Recall Campaign Bulletin

Campaign No. 2023070012, September 2023 Revision B 01/08/2024

SUBJECT: Model Various Models
Model Year 2021-2023

Replace Fuel Pump Delivery Module

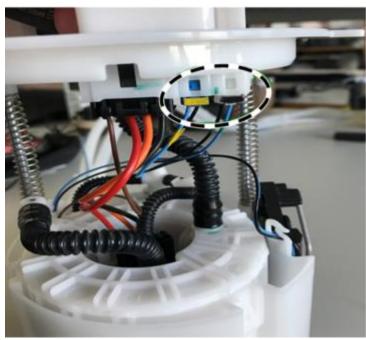
Delivery modules that are delivered without float-and-lever sensor must be modified. (Figure 3-5)

Figure 3 (release corresponding connector and disconnect the contacts)

Figure 4 (remove lines from routing clip)

Figure 5 (using a screwdriver, carefully push float-and-lever sensor housing away from module housing and at the same time push float-and-lever sensor housing upwards.)
